# WATER QUALITY M E M O R A N D U M

## Utah Coal Regulatory Program

RE: 2011 First Quarter Water Monitoring, Plateau Mining Corporation (PMC), Willow Creek Mine, C/007/0038, WQ11-01, Task ID #3767

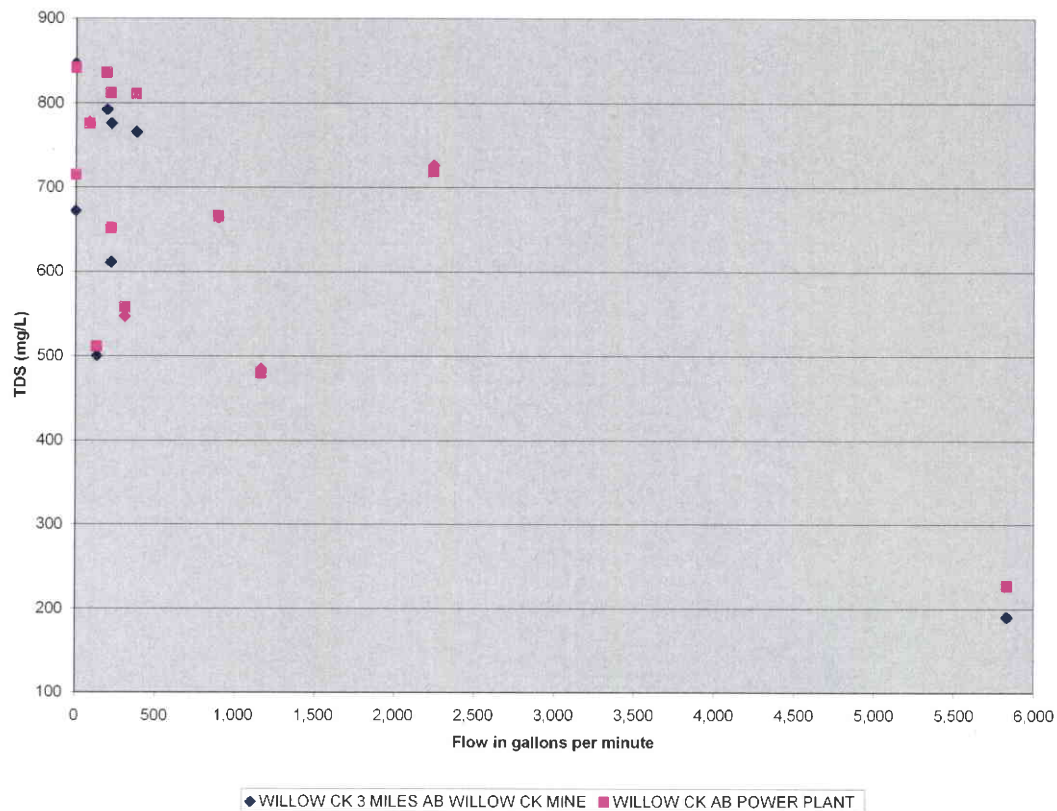
Flows were exceedingly high (approximately 6,000 gallons per minute) in Willow Creek and therefore, constituents such as dissolved calcium, magnesium, sulfate and TDS were much lower than their average reported values. Total suspended solids values were expectedly much higher due to the high flow conditions.

In general, reliability checks for total dissolved solids (TDS) relative to measured conductivity show a TDS result remaining between 55 – 75% of the conductivity value. Given the abnormal flow rates during the winter quarter 2011 at the Willow Creek monitoring stations, reliability checks for TDS values were not reviewed. The scatter plot below demonstrates the TDS concentrations in stream samples located 3 miles above the former Willow Creek mine and a stream sample below the former Willow Creek mine portals. As can be seen on the chart, TDS concentrations are highest when flow rates range between 0 to 500 gallons per minute. TDS rates dropped significantly during a reported flow rate of approximately 5,834 in March 2011.
